## Chair of Frodsham Town Council's response to Solar farm application.

This is a personal response from Helen Hayes, Chair of Frodsham Town Council. The Council will be officially responding to the Solar Farm application via the Frodsham Neighbourhood Plan group.

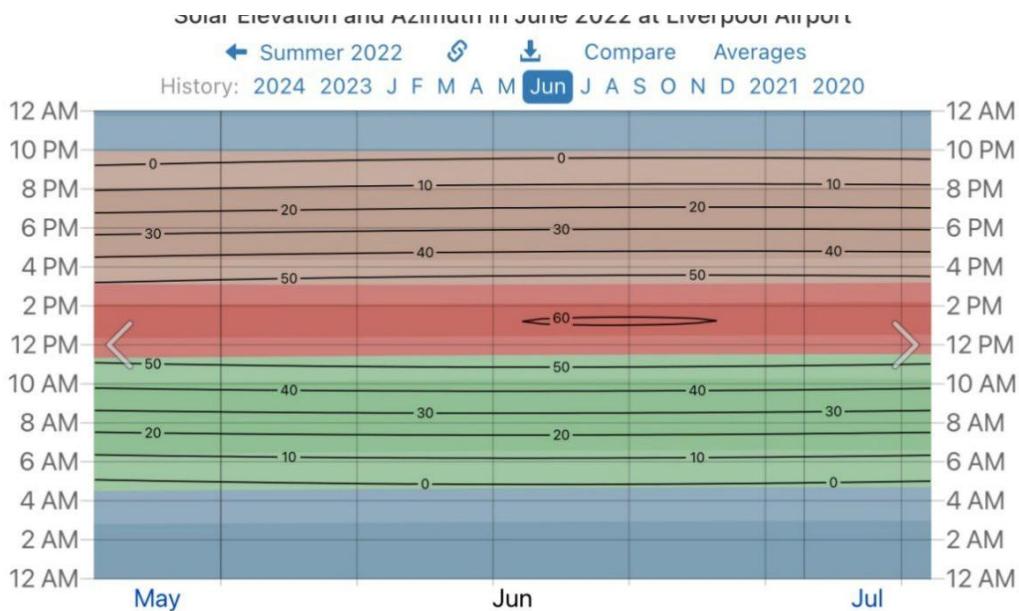
Examination of the power output curve shows that virtually no electricity was generated before 07:30 am. This is to be expected as the sun will be at low elevation and in the east, at right angles to the panels and will be approaching the panels at very low intensity. At about this time however power begins to be generated at an increasing rate as the sun moves both southwards and in front of the panels and its elevation increases. Comparison of this time with the published data for the sun's elevation (June 2022) at Liverpool airport shows it to be approx. 20° at 07:30.

Screening could be sited in front of solar panels, without significant loss of PV output, so long as they do not block out sunlight approaching the panels at an elevation of  $20^{\circ}$  or higher.

## Illustration of impact of 7m & 8m tree screens on sun's access to solar panels in mid-June.

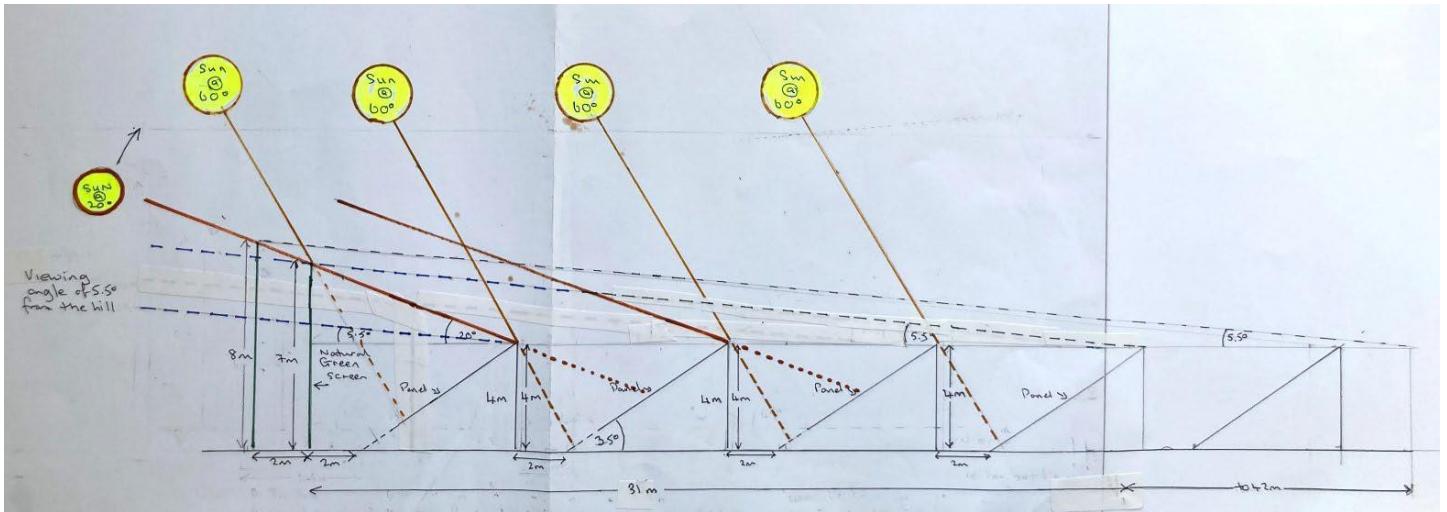
Recognising this fact, placing a tree screen in front of each row, the top of which presented an angle of 20° to the front panel, would not affect the solar power generated for all but the front row. For illustration purposes, the diagram illustrates how 7 or 8m high screens can be as close as 2-4 m respectively, to the front row. As trees naturally have different sizes & shapes, suitably shaped trees would need to be placed in front of each block of arrays such that a 20° angle was maintained.

Importantly the illustration shows that, as the viewing angle from Frodsham hill is only 5.5° for the nearest array of panels, a row of 7-8m high trees would screen from view approx. 31-42 m of the panels behind the front row of panels. This screening benefit would increase to approx. 70-93m for the most distant panels and the extent of screening would be approximately doubled when viewed from Helsby hill.

Note 1: the trigonometry (Appendix 1) shows that for every 1m that a screen is above 4 m there is ten-fold increase in the screening benefits for the closest blocks of arrays.

1. Use of natural screens of trees, bushes and shrubs in front of each section of panels.
2. Varying the heights of the natural screens over a range of 7- 8m and also varying the distances from the front of the panels and the width of the screens.
3. Frequently softening the straight lines and edges of the rows of panels.
4. Leave open areas within the largest sections of panels and create small copses of trees and bushes.
